|  N54°39.3' E024°03.5' | <h1>Technical Note</h1> | Doc. No. 017.25.001 |
| "SA ir Ko" EASA.AP160 | Replacement of the shunt screws | Page 1 of 3 |

Subject: FES system: improved screw connection of the connection cables to the shunt.

Applicability: LAK-17B FES – all serial numbers;
LAK-17B FES mini – all serial numbers up to sn 046 (inclusive);
LAK-17C FES – all serial numbers up to sn 309 (inclusive);

Figure 1

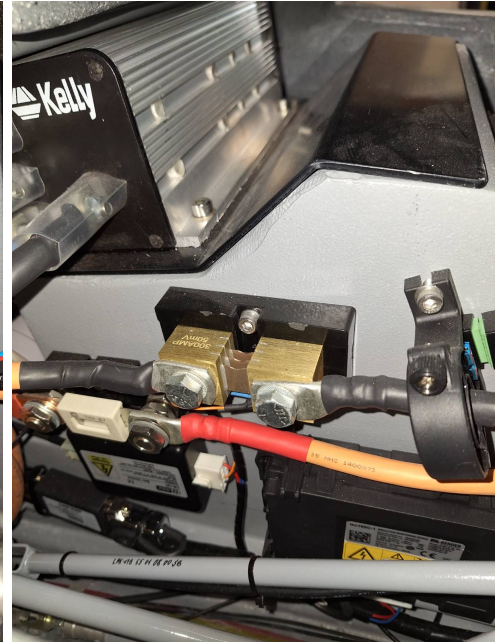
Reason: A shunt (small resistor) is installed in the cable between the negative pole of the battery and the controller to measure the current from the FES batteries. The screw connections of the large connection cables on the shunt were originally made with brass screws. These brass screws have torn off in several cases, possibly due to excessive tightening torque. To make this screw connection more robust and reliable, the brass screws are replaced by steel screws.

Whether the screw connection is made with steel screws (galvanised, light silver colour) or brass screws (bright brass) can be seen through the main spar window. (fig. 1a, fig 1b).

1. Verify the type of screws. The shunt is located on the left wall of landing gear box.
If the screw connection is already fitted with steel screws, no change is to be made.
2. If the screw connection is made with brass screws, these must be replaced with steel screws in accordance with the accomplishment instructions provided in this document.

Figure 2

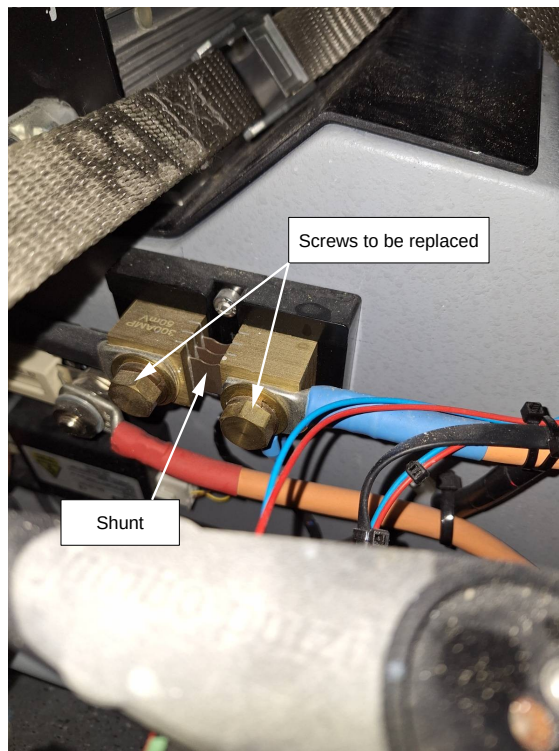
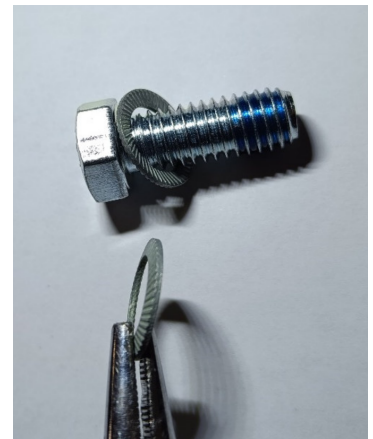
The shunt is located under the plastic cover, on the left wall of landing gear box (Fig. 2a).

After removing the plastic cover, the brass screws including the brass washers on the shunt connections can be removed. When installing the new steel screws with the new lock washers, ensure the correct orientation of the lock washer (Fig. 2b). The steel screws are additionally secured in the threaded area with medium-strength screw locking adhesive (Loctite 243 or similar). The tightening torque is 17 Nm. The plastic cover must then be refitted.

The brass screws previously used to fasten the high-current cables to the shunt must be replaced with steel screws.
